STAFF REPORT
KETCHUM PLANNING AND ZONING COMMISSION
SPECIAL MEETING ON SEPTEMBER 27, 2022

PROJECT: McGavick Residence

FILE NUMBER: P22-048

APPLICATION: Pre-Application Mountain Overlay Design Review

L-4.01

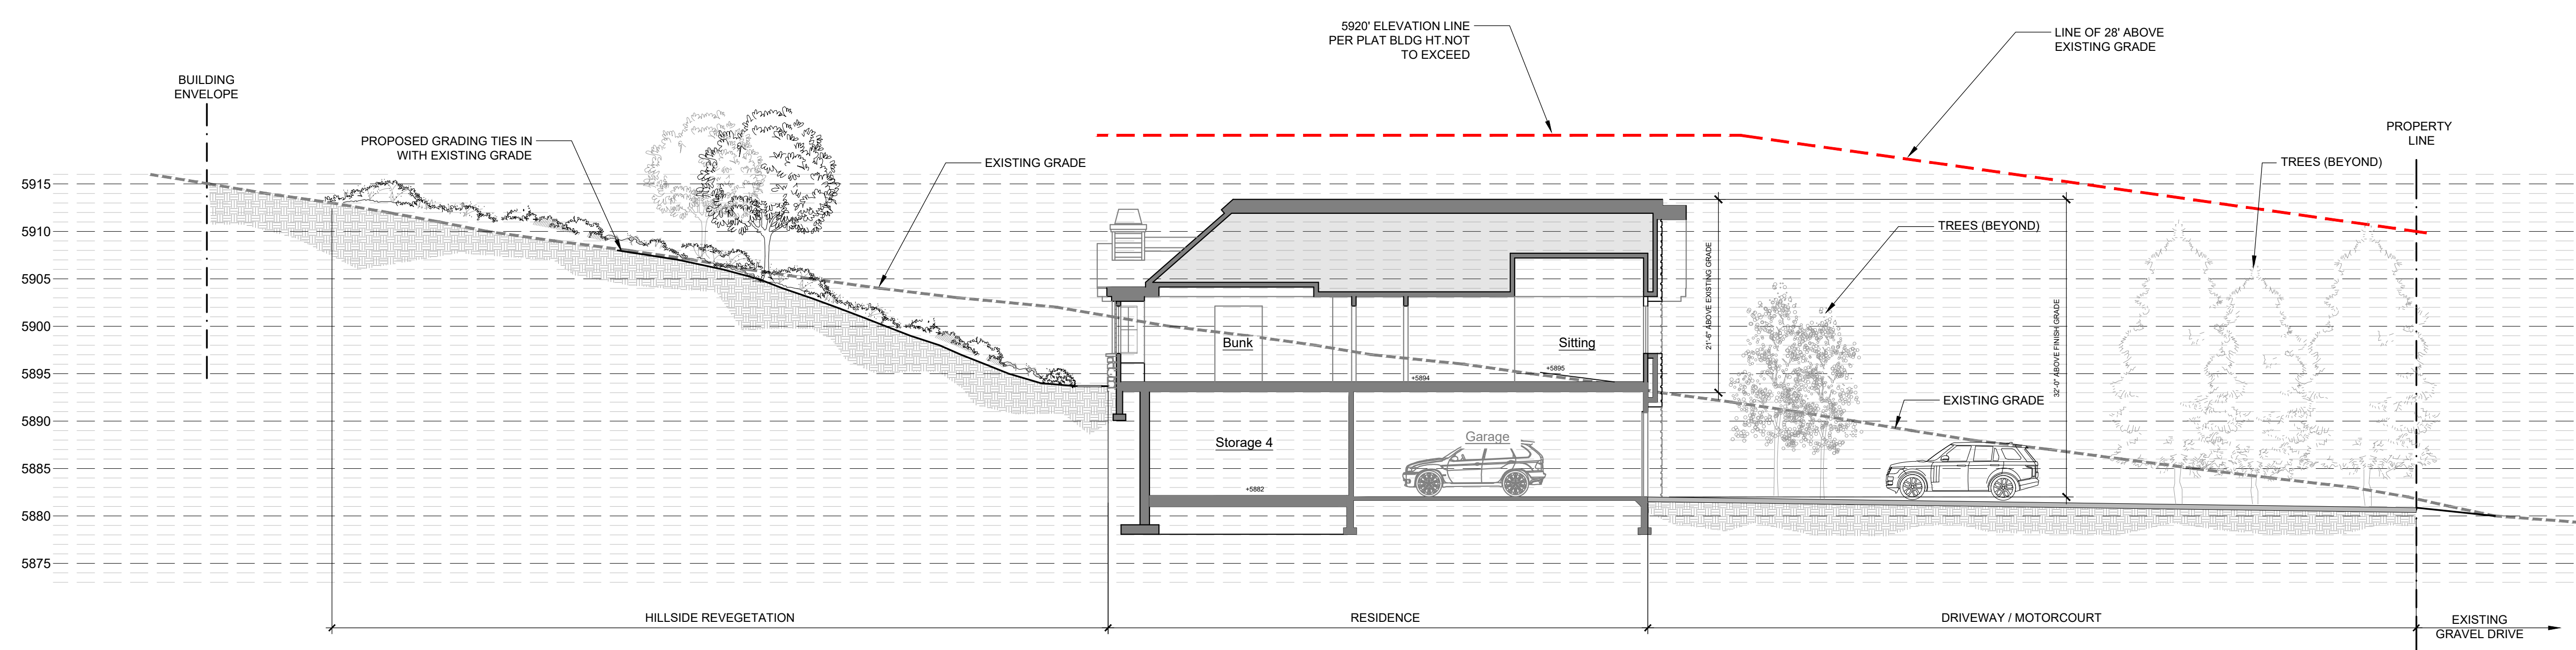
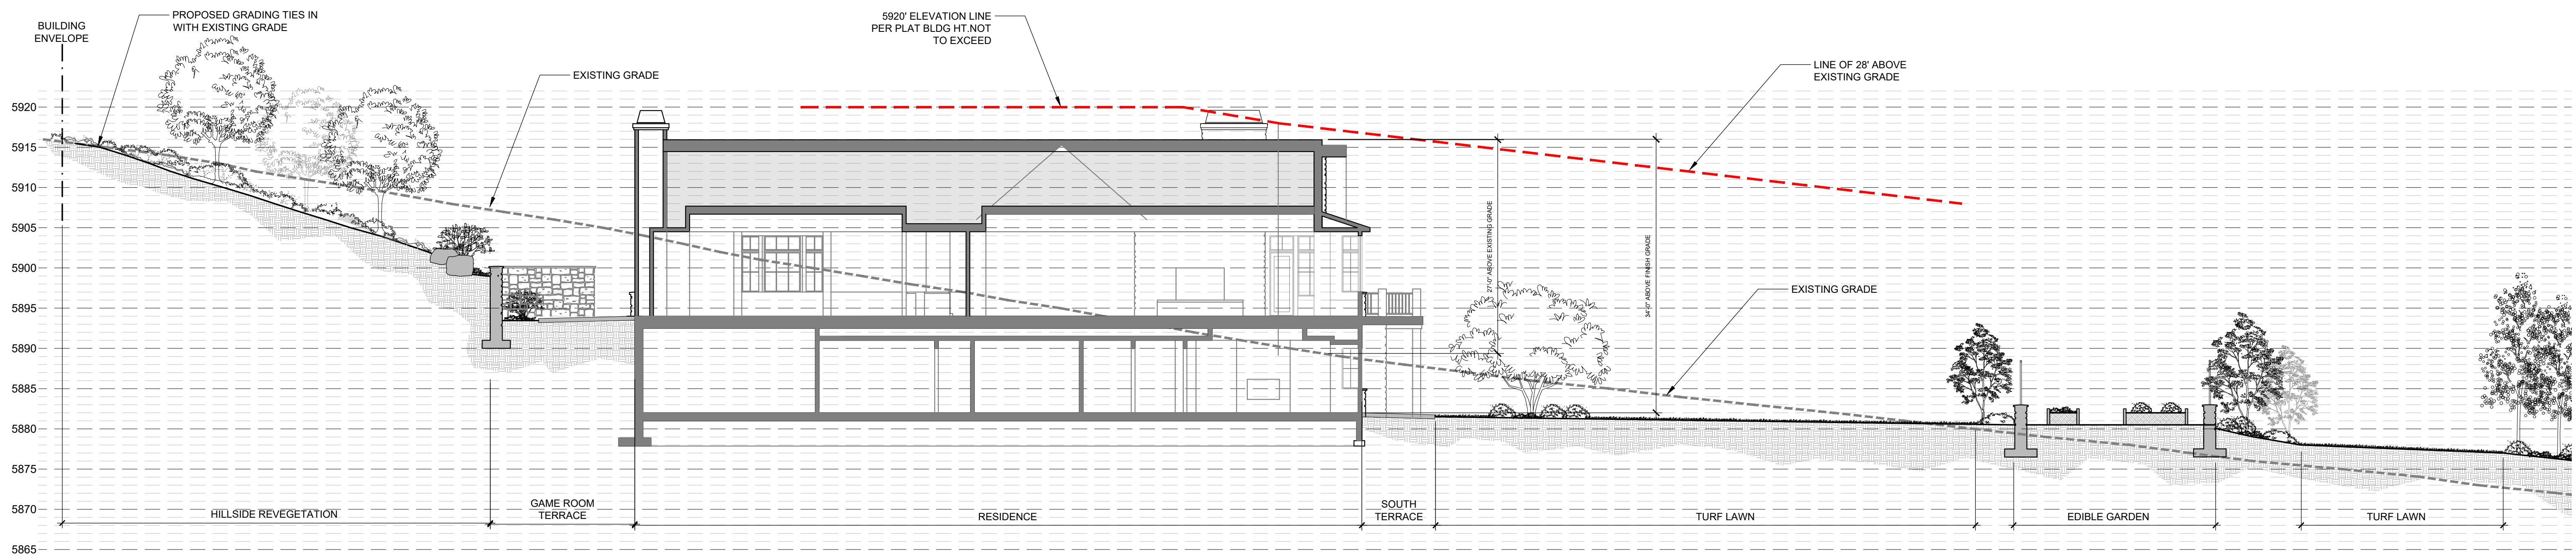
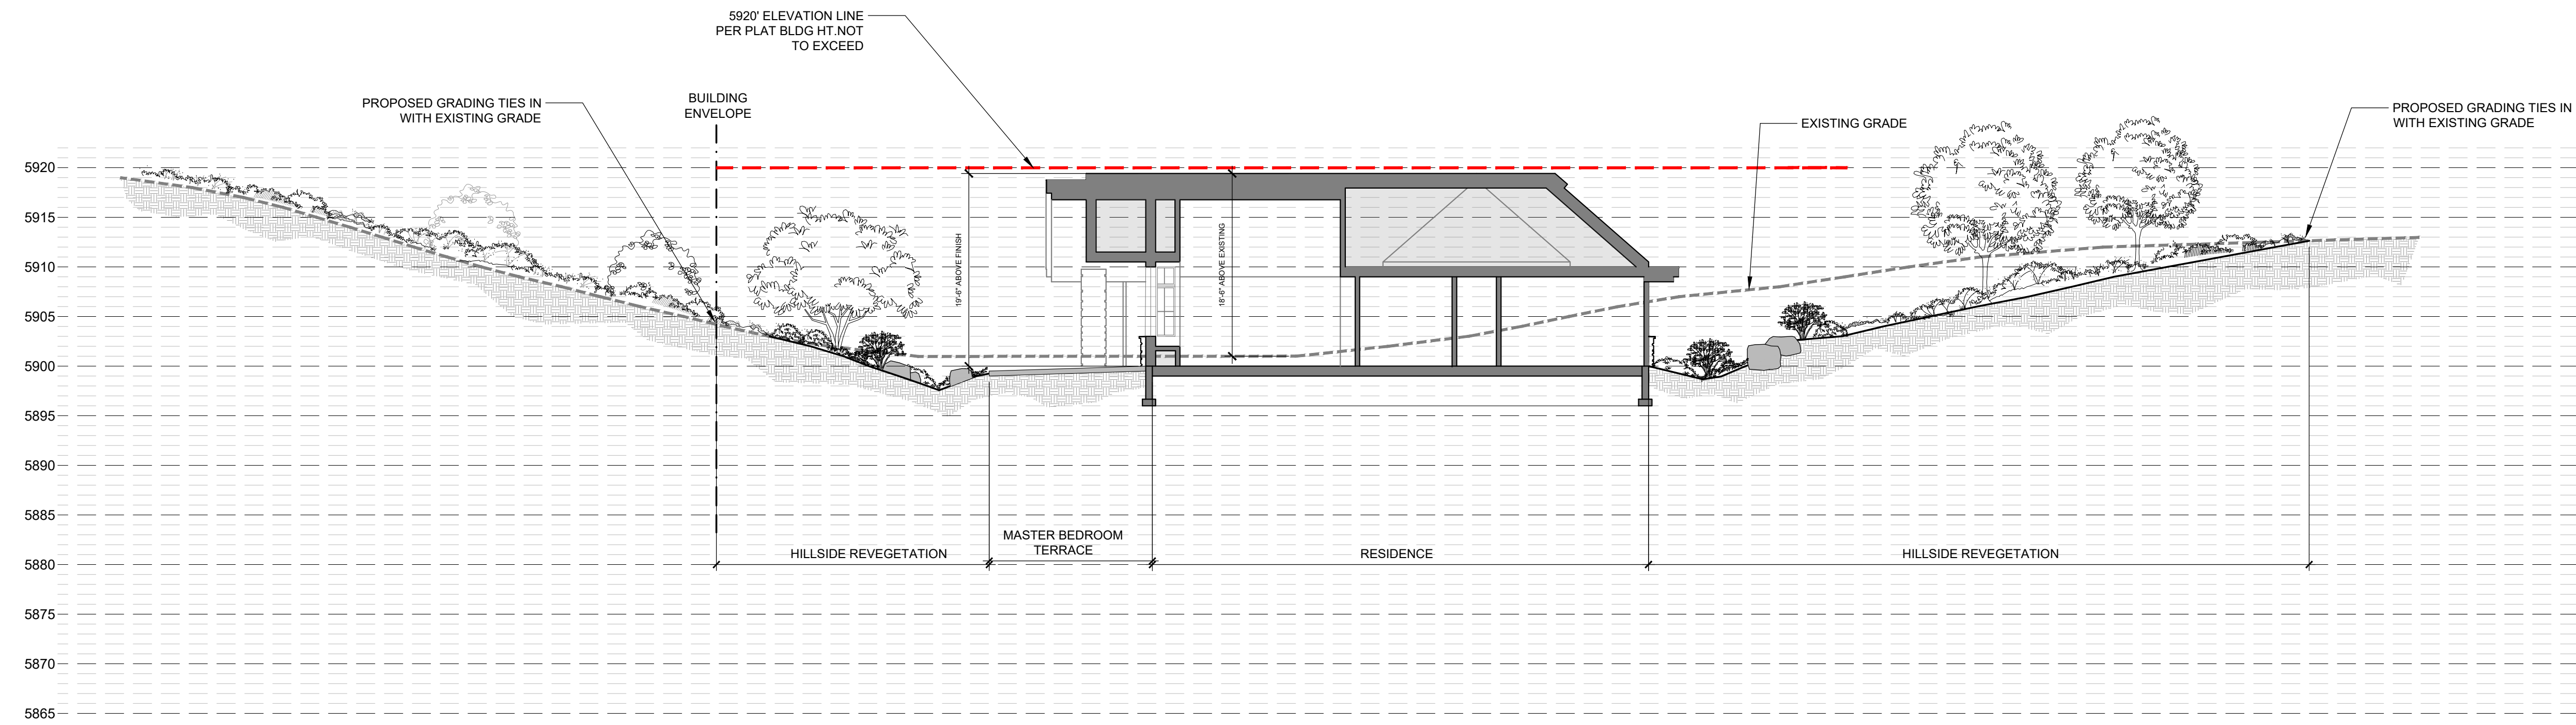
Sheets L4.01 through L5.01 show the locations of sections in plan view and section cuts for the building height calculations for the proposed project. The red line shows the elevation of 5920 on all three sections. As shown on Section 2, the red line shows not only the 5920 limitation but also the line of 28 feet above existing grade. Section 2 indicates the total building height from finished grade is 34 feet. Section 2 also shows the total building height does not exceed 28 feet above existing grade with the exception of the chimney, which is permitted as it does not exceed the elevation of 5920 feet.
